ADDENDUM # 1

11/9/12
RFP #7458195

Title: Replacement of Unit Ventilators and Exhaust Fan.

Notice to Vendors: Inadvertently one (1) drawing was omitted from bid.

UniVent-Electr

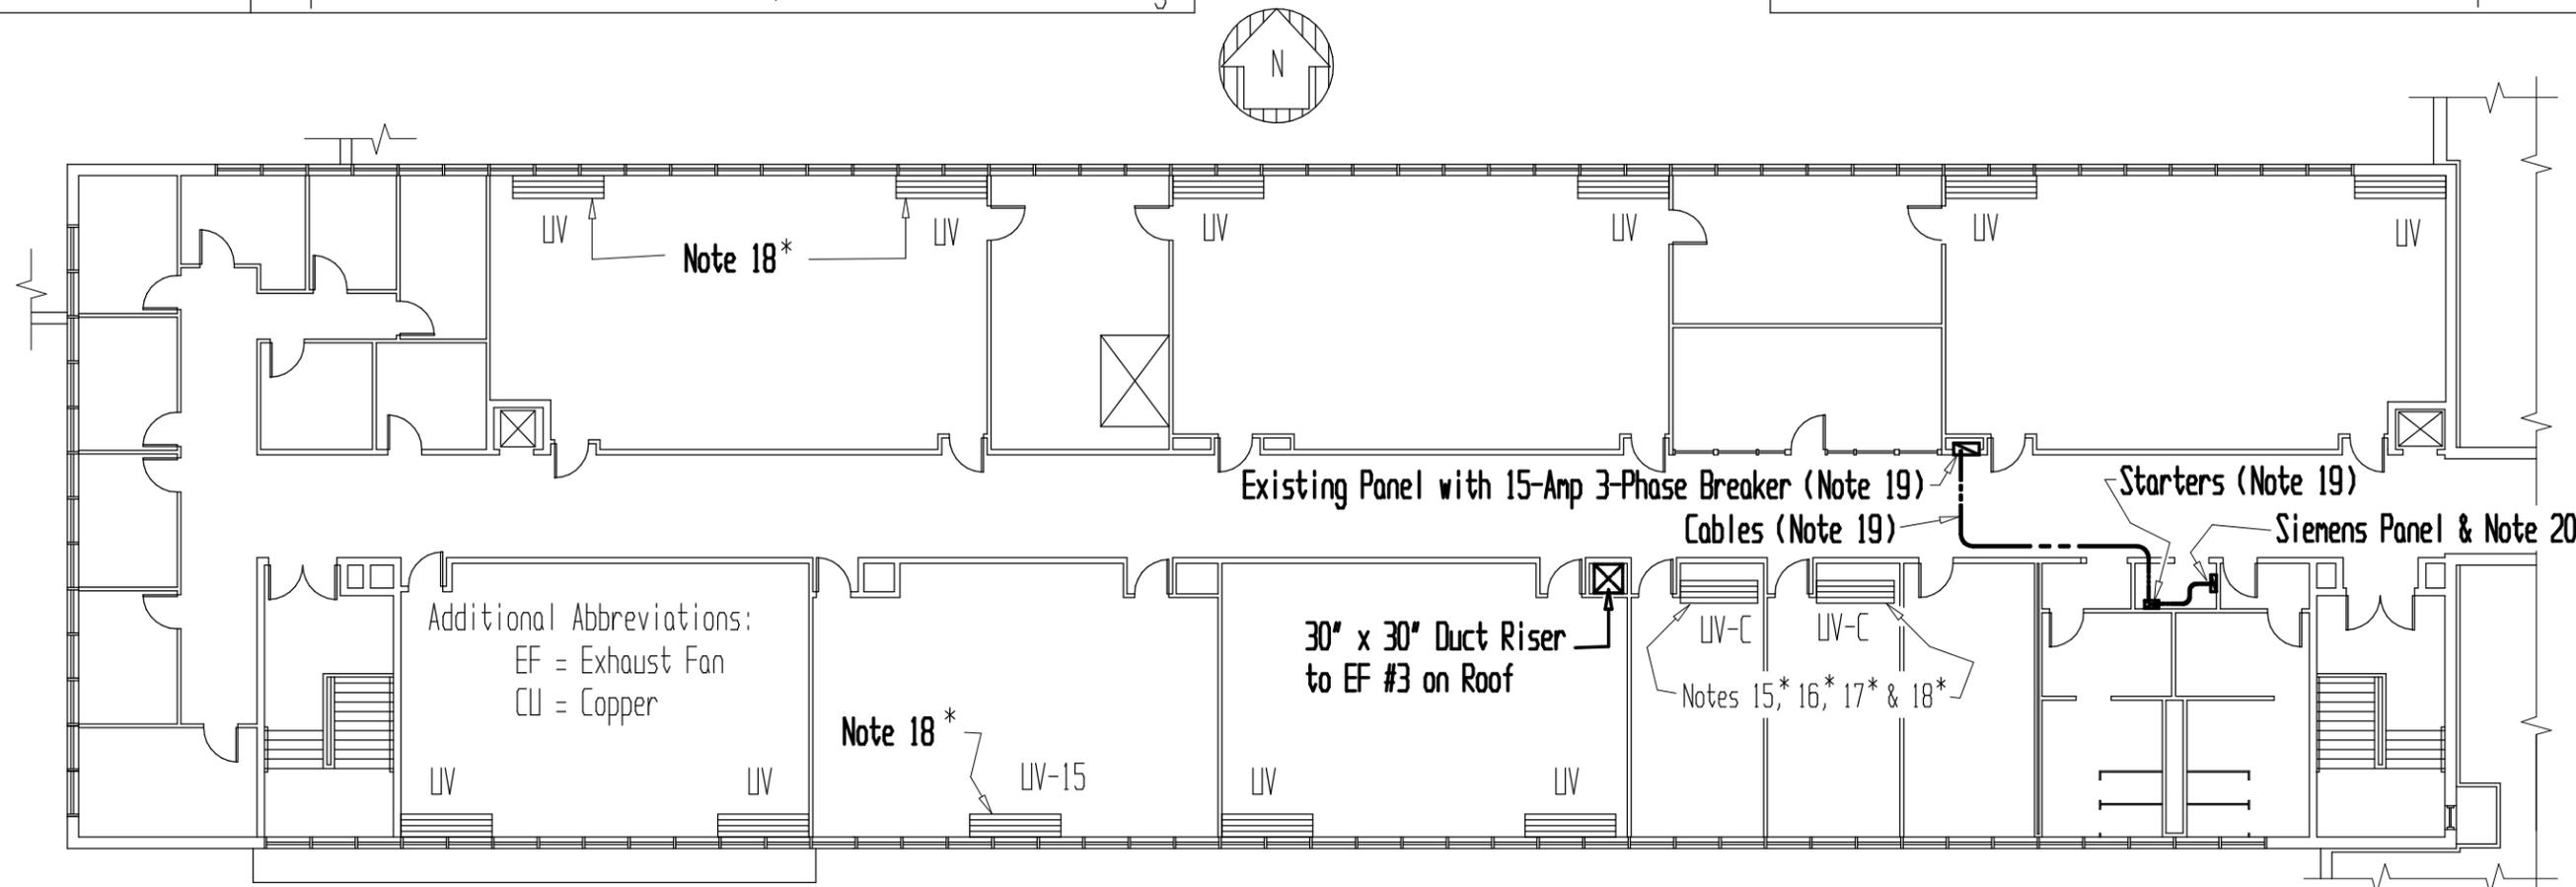
- 17. GENERAL - ADDED: In addition to the Requirements of Notes 15, 16 & 17, & Because the RA Openings on the Replacement Ceiling-Mounted Univents are Located on the North Face of Each Ceiling-Mounted Univent; Contractor is to Ensure that EACH of these FOUR Univents is F&I at an Elevation Individually Approved by the College Engineer & with Sufficient Space Between the North Face of the Univent & Any Other Component of the Building so that the Return-Air will have Adequate & Completely UNOBSTRUCTED Access to the R-A Opening on the Univent's North Face (or Elevation).

- 18. GENERAL: All of the THREE Models of Trane Univents Specified in these PLANS can be Provided with Either LEFT-HAND or RIGHT-HAND Piping Connections. Before Ordering Any of the 25 TOTAL Required Replacement Unit Ventilators (Vertical 1500-CFM; Vertical 750-CFM; Ceiling-Mounted 500-CFM), Contractor is to Open EACH of the 25 Existing Univents & is 100% Responsible for Ordering the Correct Quantities: of LEFT-HAND VUVE 0750 & RIGHT-HAND VUVE 0750 Univents; of LEFT-HAND VUVE 1500 & RIGHT-HAND VUVE 1500 Univents; and of LEFT-HAND HUV 0751 & RIGHT-HAND HUV 0751 Ceiling-Mounted Univents. The Designation "Left-Hand" for a Unit Ventilator Means that the Piping Connections are in the Univent's Left-End Cabinet; and Its Electrical Connections are in Its Right-End Cabinet - as You Face the Univent; Confirm this Definition with Trane Company before Ordering.

- 19. The College Engineer Recently Discovered that Somebody had Removed the Previously Existing Exhaust Fan (EF) #3; & had Covered Over Its Roof Curb (about 32" x 32"). F&I a Greenheck or Carnes Replacement EF #3: to Exhaust 2790 CFM at 1/2" Static Pressure; & having a 1/2 HP 1725-RPM Electric Motor. Use One of Three College-Approved Roofing Contractors (Eagle Cornice; Commercial Roofing; or Gorman) to Cut the Required Roof Opening; F&I a Curb Provided by the EF Manufacturer; Secure the EF to the Curb; Flash & Seal the Curb to Johns Manville Specifications. Using G-Steel of Gauge to Match Existing. F&I Any Required Ductwork to Connect the Building's Existing 30" x 30" Exhaust Duct Riser to the Replacement EF-#3 Opening. Include a Canvas-Type (Acceptable-Fabric) Sound-Attenuator or ...

- 19. (CONTINUED)...or Vibration-Eliminating Connector between EF-#3 & Its Duct Riser. The 1/2 HP Motor is to be 208-Volt 3-Phase. Into an Existing Conduit System, F&I (Pull) FOUR #14 Copper Cables (THHN; 3 Phases + Neutral) plus Ground Wire & Connect Same to an Existing SPARE 15-Amp Breaker in this Existing Panel (North Wall of Corridor) & Connect the Opposite Ends of the Cables to the Ine (Incoming Power) Terminals of the Properly-Sized Motor Starter that the Siemens Subcontractor is to F&I. Prime Contractor is to F&I 3/4" D EMT Conduit (or Re-Use Existing) Connected Both to the Starter & to a Weather-Proof Disconnect (or Toggle Switch, if Code Allows) Contractor is to F&I in the EF Enclosure. From & Connected to the Load Terminals of the Starter, F&I FOUR #14 CU Cables plus Ground Wire & Connect Same to the Disconnect. F&I Water-Tight Flexible Conduit Containing the Same Types of Cables (if Code Allows) & Provide 3-Phase Electric Service (+ Ground) from the Disconnect to EF #3.

- 20. Siemens Subcontractor Requirements: F&I TWO 1/2" D EMT Conduits from & Connected to the Existing Siemens Panel on the East Wall of this Janitor's Closet & Connect One of these to EACH of the 2 Starters (One for EF #3 & One for EF #4). Into Each Conduit, F&I the Required Number of #18 CU plus Ground Cables to Operate EF #3 & EF #4 (On & Off Only). Also, F&I Any Additional Relays Required in EACH Starter in order to Operate the EF. (For Clarity, the Janitor's Closet Door is NOT Depicted.)
